Access Compliance Report

Public Rights-of-Way

(Curb Ramps)

Intersection ID: 28448	Main Street: SANDERS_CREEK_CT	Cross Street: SHINING_OAK_LN	Location: NW
ADA ID: DC08B25B6C8A	Ramp Type: Perp	Initial Pass/Fail: Pass	Overall Compliance: No
Severity Score: 0			
Codes/Mitigation Info/Possible Solution		Field Measurements/Component Compliance

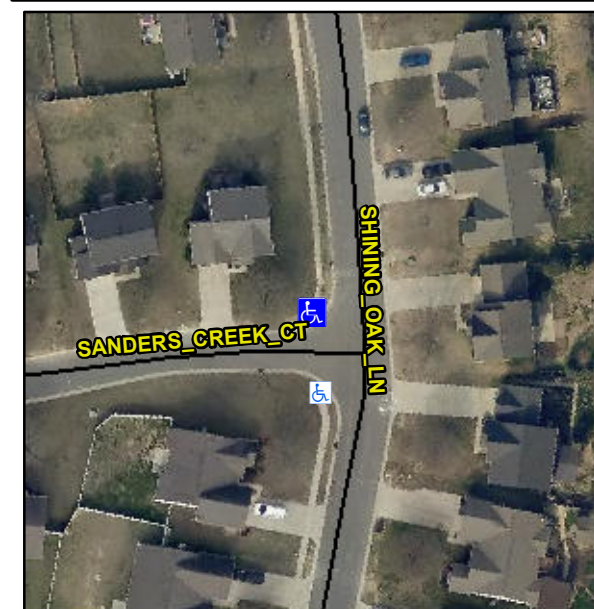
Not Found, R304.2.1, R304.2.2-Perp, R304.3.2-Para, R305.2

Compliance	Description	Data	Compliance	Description	Data
N/A	Ramp Length (in)	48.5	Yes	Ramp Slope (%)	6.3
Yes	Ramp Width (in)	48.0	Yes	Ramp XSlope (%)	0.3
N/A	Flare Type LT	None	N/A	Flare Type RT	N/A
N/A	Flare Slope LT (%)	N/A	N/A	Flare Slope RT (%)	N/A
N/A	Flare Traversable LT?	N/A	N/A	Flare Traversable RT?	N/A
No	Landing Length (in)	47.0	Yes	DWS Provided?	Yes
Yes	Landing Width (in)	48.0	Yes	DWS Contrast?	Yes
No	Landing Slope (%)	4.8	Yes	DWS Length (in)	24.0
Yes	Landing X Slope (%)	0.3	Yes	DWS Full Width?	Yes
N/A	Landing Curb? (Y/N)	No	No	DWS Offset (in)	3.0
N/A	Shared Landing?	No			
Yes	Gutter Ponding?	No	Yes	Gutter Slope (%)	3.8
Yes	Gutter Lip Ht (in)	0.0	Yes	Gutter X Slope (%)	1.8
N/A	Painted X Walk1?	No	N/A	Painted X Walk2?	N/A
	X Walk 1 Direction	To S		X Walk 2 Direction	N/A
N/A	X Walk 1 Width (in)	N/A	N/A	X Walk 2 Width (in)	N/A
	X Walk 1 Slope (%)	1.4		X Walk 2 Slope (%)	N/A
	X Walk 1 X Slope (%)	2.0		X Walk 2 X Slope (%)	N/A

N/A	Ramp inside XWalk1?	N/A	N/A	Ramp inside XWalk2?	N/A
	Road Slope (%)	N/A	N/A	Clear Space?	Yes
	Road X Slope (%)	N/A	N/A	Clear Space to XWalk (in)	N/A
Yes	Any Obstructions?	No	Yes	Storm Grate/Utility Hazard?	No
	Obstruction Type			Storm Grate/Utility Type	
		N/A			N/A
			Yes	Surface Condition? (G/P)	Good

Remove & Replace Entire Ramp.
